DESIGN REVIEW COMMISSION AGENDA

Tuesday, September 17, 2024 – 6:30 P.M.

1. Chipotle, 6600 Stage Road (Shawna Fuhrman, Dungan Design Group)

DESIGN REVIEW COMMISSION
Tuesday, September 17, 2024 – 6:30 P.M.
Bartlett City Hall Assembly Chamber
Staff Comments

Exterior Elevations

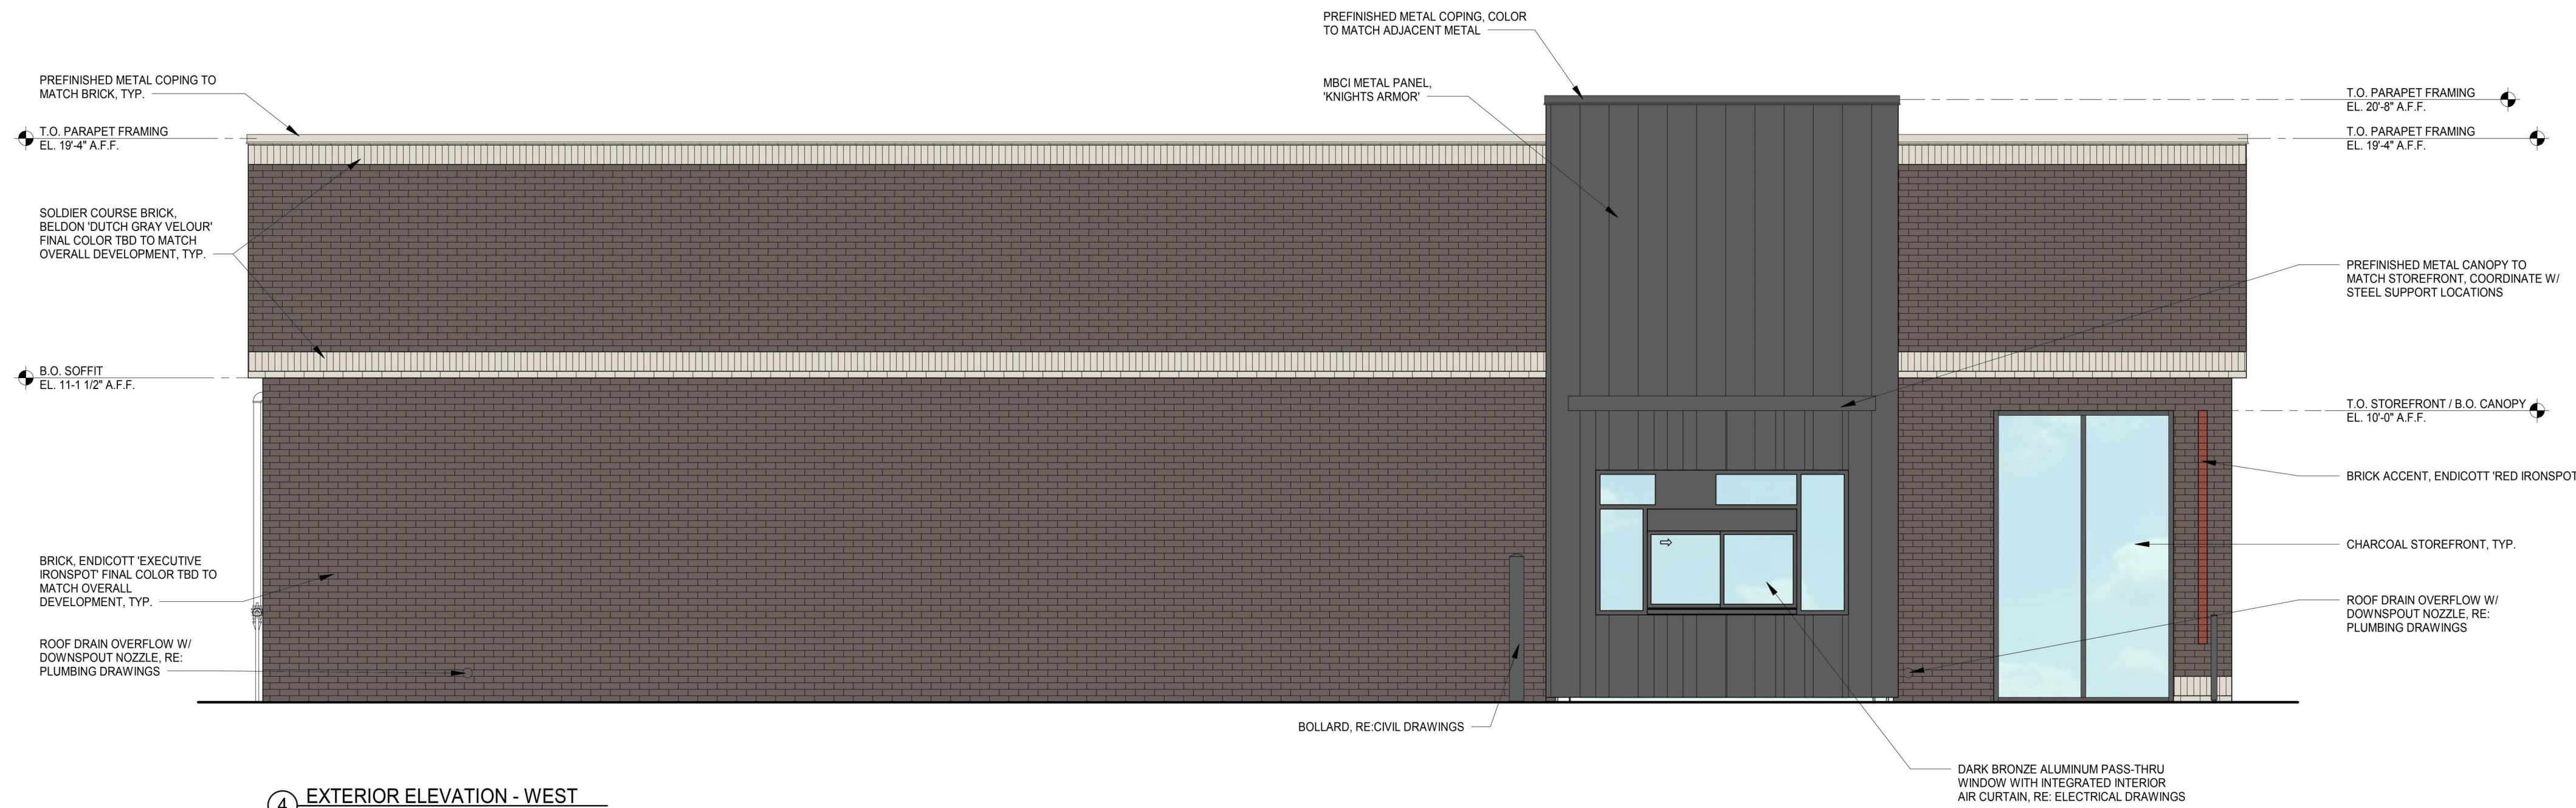
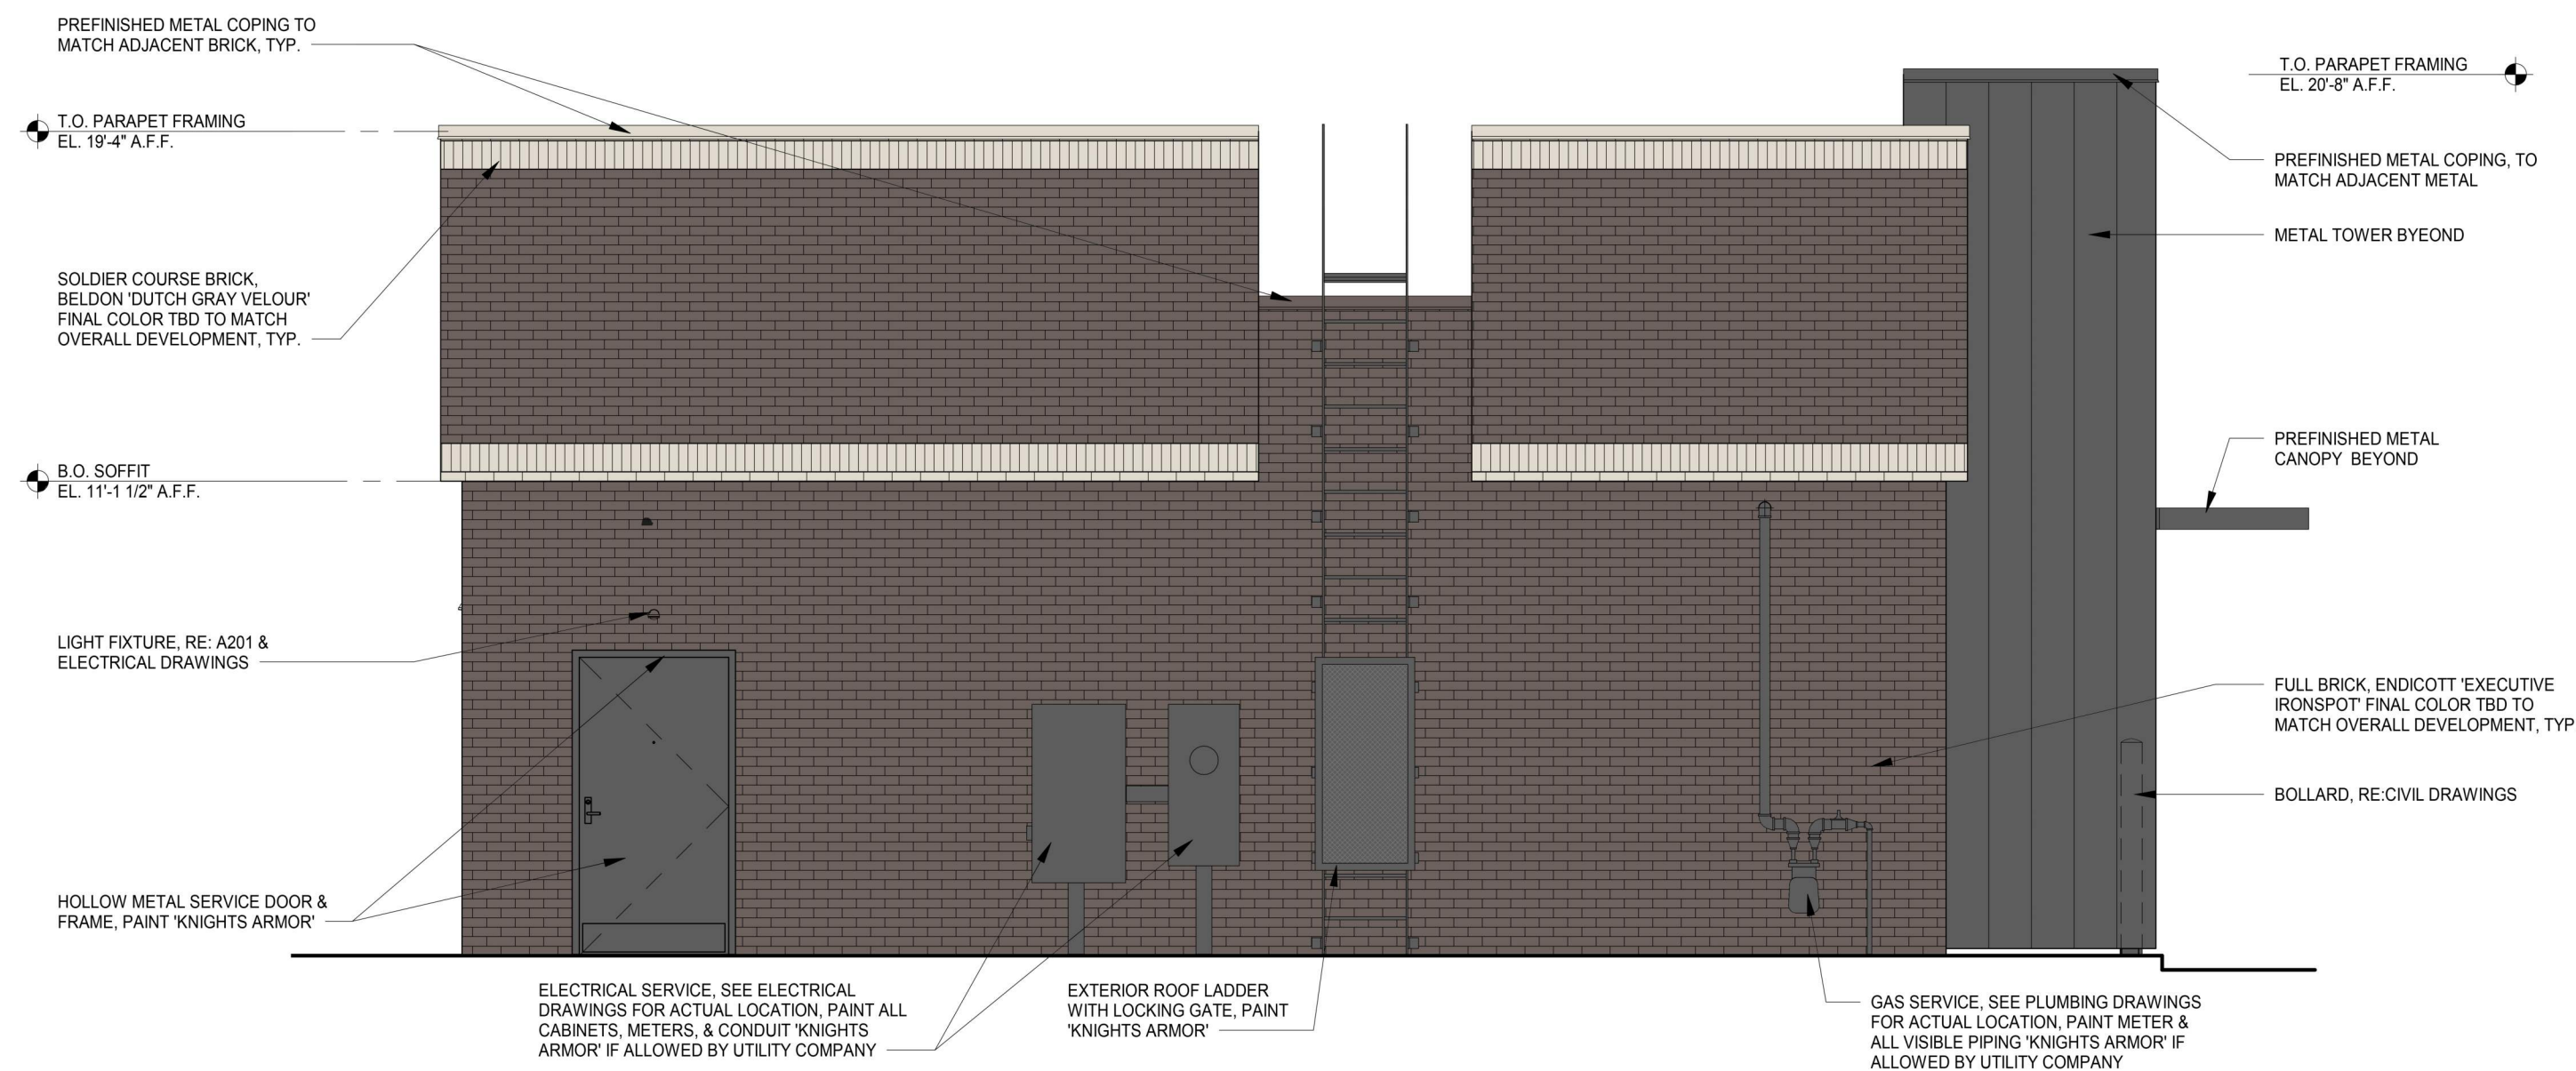
1. The applicant shall include a site data table on the Site Plan.
2. The applicant shall identify all paint brands and colors on the exterior material legend.
